THE NETWORK RAIL (LEEDS TO MICKLEFIELD ENHANCEMENTS) ORDER (REF DPI/N4720/23/19)

Statement by P E H Ward on behalf of Leeds City Council to Public Inquiry

This short statement expands on Statement of Common Ground in relation to the impact of the proposed signal gantry on the Kirkgate to Marsh Lane land (HUL4/44) at Penny Pocket Park in Leeds city centre.

Figure 37: General Arrangement of the Kirkgate to Marsh Lane Land

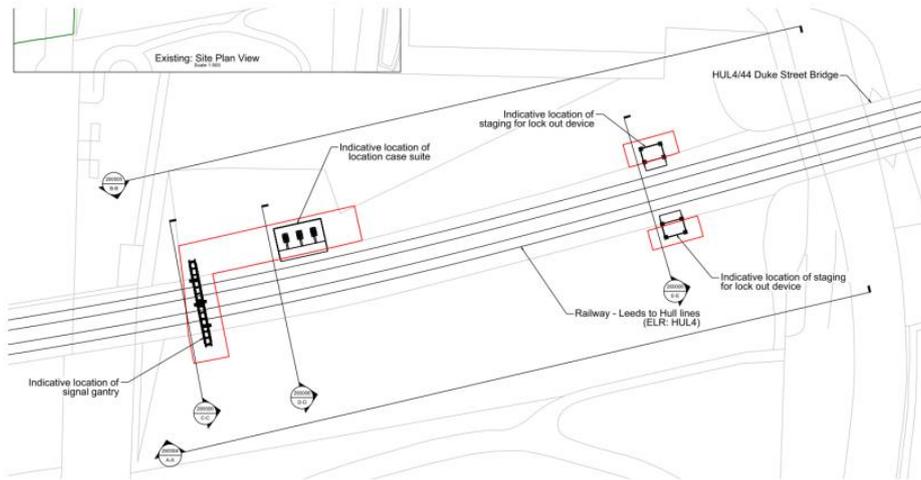
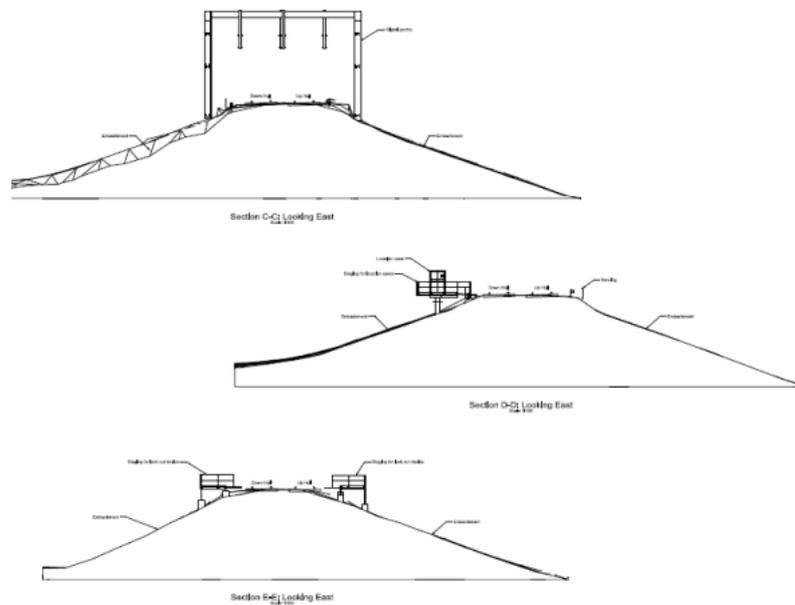
There is an existing signal/light on a post with access and protective cage some 10m high on the site of the proposed gantry and it is assumed that it will be removed. The proposed design of the replacement lighting gallery is shown on pages 63-65 of the Environmental

Report Doc NR15: Design and Access Statement which are reproduced in appendix 3. In simple terms, the replacement light gallery is a goalpost design spanning the track with light hanging from the “cross bar”.

The existing lighting/signal is a one-dimensional vertical object whereas the proposed replacement lighting gantry is a horizontal two-dimensional object which frames views and encloses space and has a different and more significant visual impact. Similar gantries over the line already exist further east along the line attached to the viaduct over Duke Street for comparison.

The proposed gantry will be more visible than the existing structure in the views discussed above. Instead of the structure being lost in the overwhelmingly vertical array of the trees as currently pertains, in the view from the Minster and across the Pocket Park from the east in view 5, the skyline above the viaduct will be crossed by the gantry. In views 2 and 4, the gantry will not be filtered by trees and will be juxtaposed against the silhouette of the Minster where it will not be seen as a single vertical point but as more complex figure with lighting which will further detract from the primacy of the listed building.

The harm to the setting of the listed buildings and the conservation area is considered to be towards the bottom end of “less than substantial”. Nevertheless, any harm to heritage significance, regardless of the level, needs to be demonstrated to be necessary and have a "clear and convincing justification" (para 206) before weighing it against the public benefits, as required by para 208 of the NPPF.
